# Expert Report on Drainage/Hydrology

Craigieburn West PSP

19 April 2021

<b>Report Author:</b>	Warwick Bishop
<b>Title:</b>	Expert Report on Drainage/Hydrology
<b>Address of Property:</b>	Criagieburn West
<b>Report Prepared For:</b>	Hume City Council
<b>Instructed By:</b>	Maddocks
<b>Date of Report</b>	19 April 2021
<b>Document Name</b>	21010410_R01v01b.docx

**FIGURE 7-2 REFINED GAP CATCHMENT AREAS**

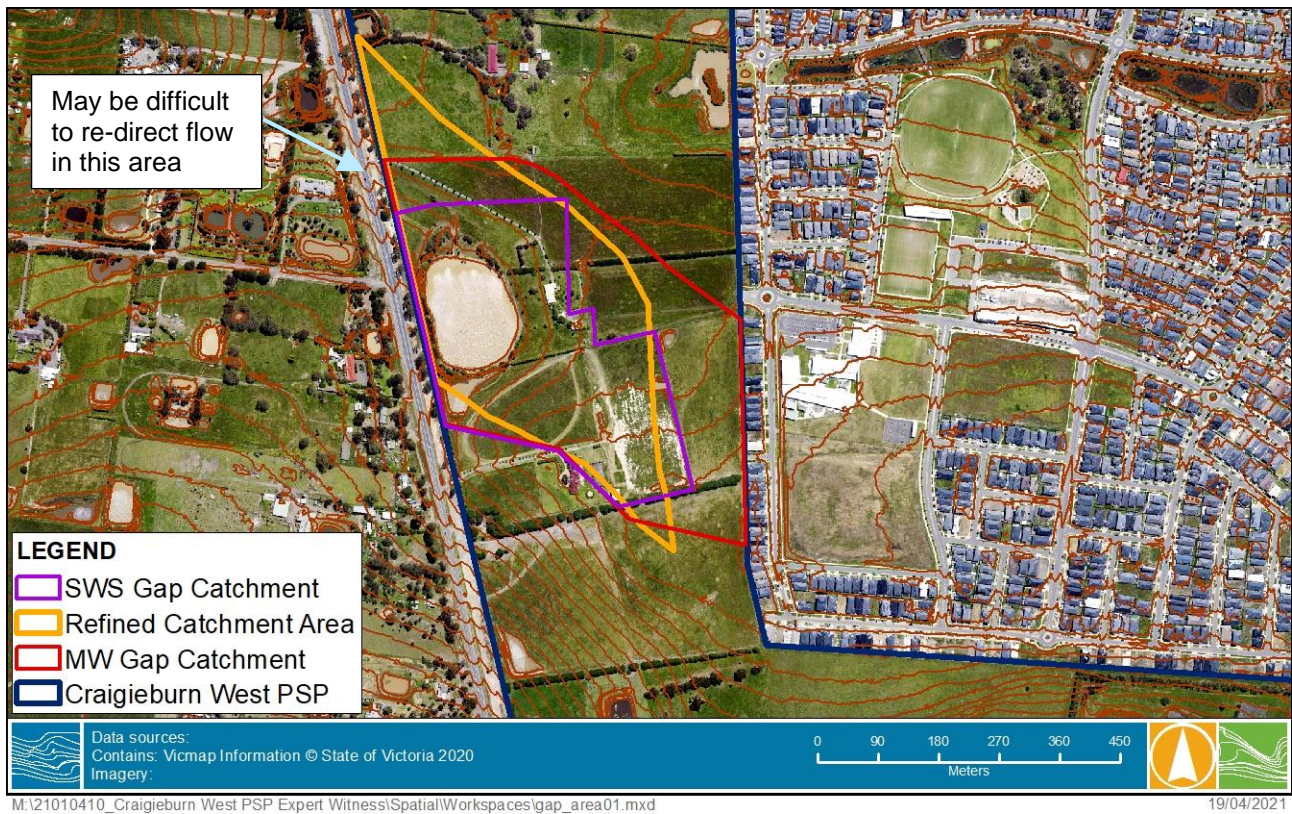
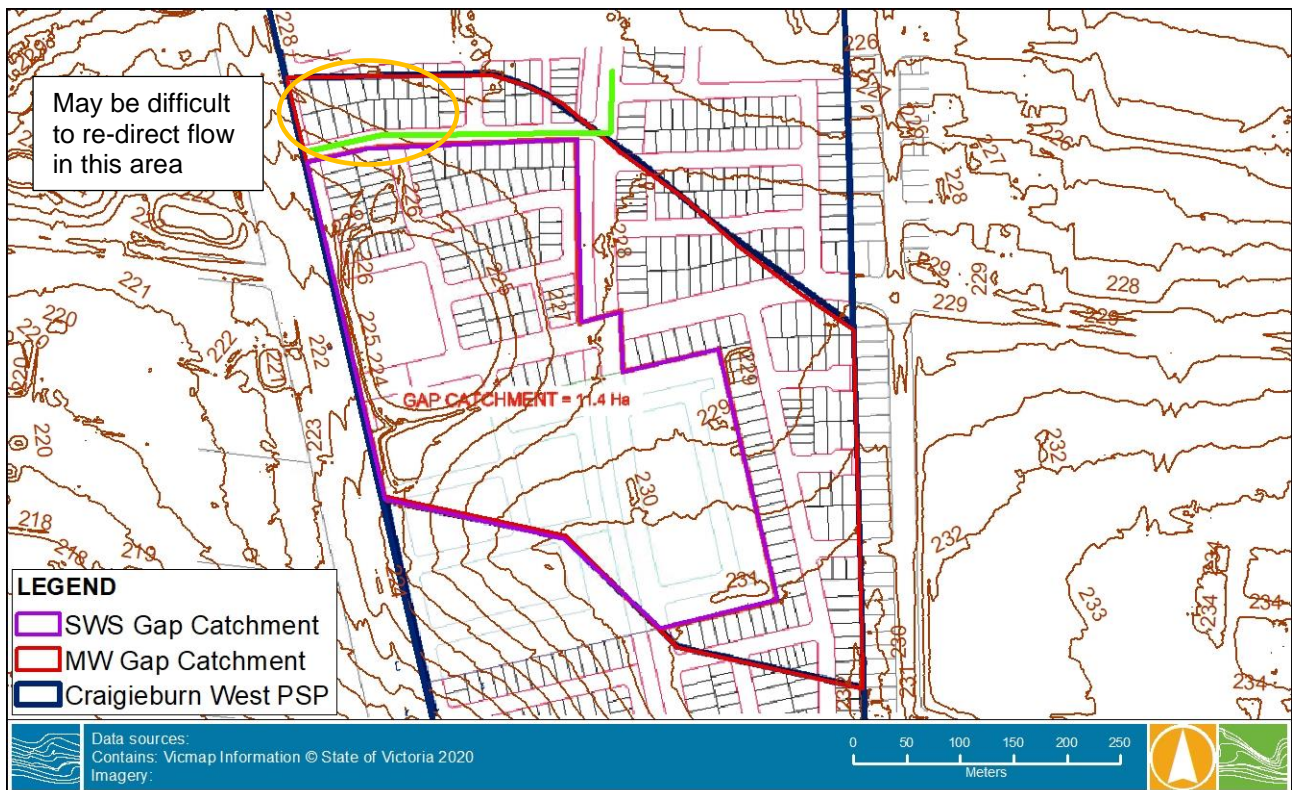
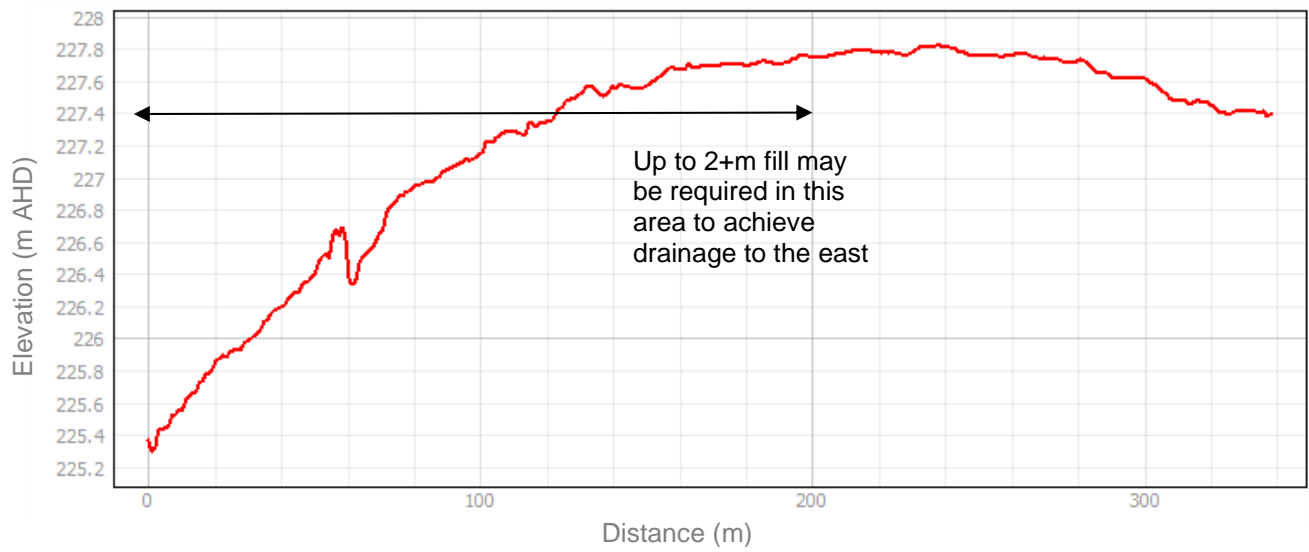
I believe the SWS proposed gap catchment is an appropriate response to the issues highlighted above. There is a small area in the north-west corner that may be difficult to drain without fill of up to 2 m (or slightly more) to achieve grade to the east. This is shown in Figure 7-3, with a longitudinal section along the nominal boundary road shown in Figure 7-4. I do not consider this to be a significant issue and can either be resolved through civil design or the boundary slightly adjusted.

I have reviewed the proposed Stormy Water Solutions design for a sediment basin, retarding basin and bio-retention system. I believe the design is appropriate and could achieve the desired outcome. There is ample elevation between the current base of the dam and the land surrounding the dam, which rises steadily, to implement the bioretention swale and match the culvert invert levels to achieve outfall.

I understand that two assets were previously proposed, however I believe a single asset in this catchment is a far better design solution. Dual assets in a small catchment are inefficient as they require additional reserve area to accommodate batter slopes, access paths and maintenance areas. The logical position for a treatment asset in this catchment is at the lowest point which is inside the footprint of the existing dam (property 31). A second asset located in property 32 would fall outside the dam and not in the lowest part of the catchment. This would also require excavation of higher ground and filling of a larger portion of the dam which is inefficient from an earthworks perspective.
